HISTORIC AND DESIGN REVIEW COMMISSION

HDRC CASE NO: 2018-572
ADDRESS: 122 W AGARITA AVE
LEGAL DESCRIPTION: NCB 1768 BLK 3 LOT 4 & W 25 FT OF 5
ZONING: R-4 H
CITY COUNCIL DIST.: 1
DISTRICT: Monte Vista Historic District
APPLICANT: Robert Murray, AIA/Shawn Kaarlson & Associates - Architects
OWNER: Mark and Jeffrey Wade
TYPE OF WORK: Exterior modifications to rear accessory structure
APPLICATION RECEIVED: November 14, 2018
60-DAY REVIEW: January 13, 2018
REQUEST:

The applicant is requesting a Certificate of Appropriateness for approval to:

3 NEW - REAR ELEVATION
1/4" = 1'-0"

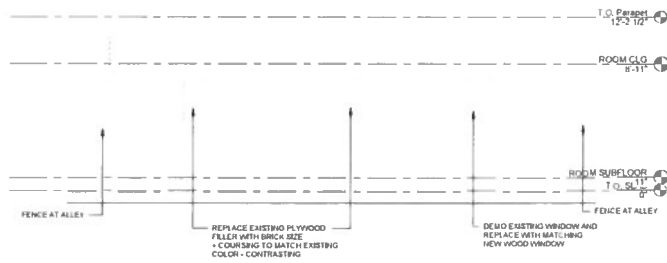
- b. FRONT ADDITION – The applicant has proposed to install a front addition to the existing rear accessory structure. The addition will add approximately 4 feet in depth to a portion of the front façade. The addition will be constructed of wood frame clad in beveled teardrop wood siding and will feature a low-sloping shed roof with barrel tile and gutter detailing to match the primary structure. Two wooden garage doors will be installed on the front façade. Staff finds the proposal appropriate given the location of the rear accessory structure and the architectural detailing.

Item 1, Staff recommends approval of the front addition based on finding b.

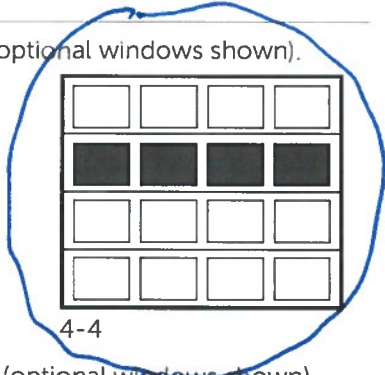
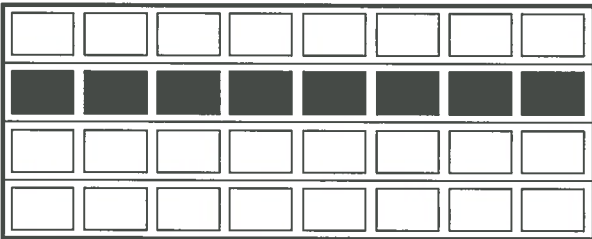
- c. GARAGE DOOR REPLACEMENT – The applicant has proposed to install two new wooden overhead garage doors to replace the existing. The proposed doors are single width and will feature four rectangular lites. Staff finds the proposed doors appropriate.

Item 2, Staff recommends the approval of the garage door replacement based on finding c.
